Replacement of 2931842XXX (2-Way) and 2931843XXX (3-Way) Lower Power Modules

REFRIGERATOR
BULLETIN R73/5A
JULY 1995

Wire Harness Kits 3108702.675 (7,11 & 12 Series)
and 3108702.683 (7130 & 7030) Must be Installed
Along with Power Modules with Purple Connectors

FIG. 1

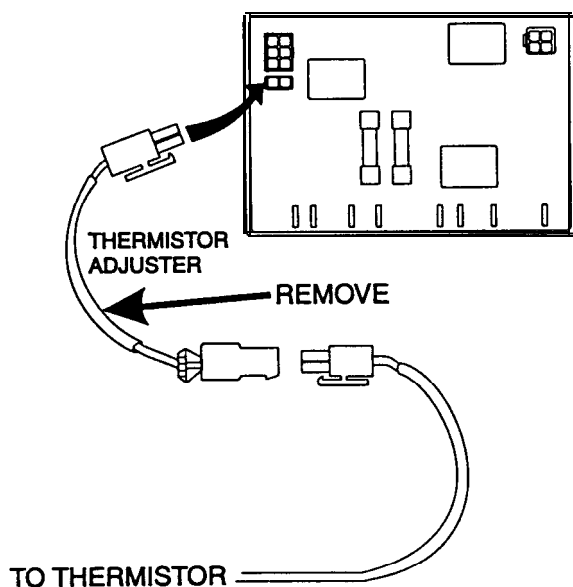
1. When installing the power module with purple connections, examine the thermistor connection on the board. If there is a thermistor adjuster added in the line between the end of the thermistor and the board, it **MUST** be removed. (See FIG.1) **Failure to do this can result in an over-cooling condition.**
2. When disconnecting the thermistor cable, examine the end for heat shrink jacket (yellow or white with yellow lettering). If this heat shrink jacket is present on the cable: carefully peel it back. This will expose a small resistor. This resistor needs to be removed from the cable by simply cutting both bare wire leads. Reconnect the cable to the new board. **Failure to remove this resistor can result in an over-cooling condition.** (See FIG. 2)

NOTE: When replacing these Power Modules, it is imperative that the new wire harness kits (3108702.675 3108702.683) be used.
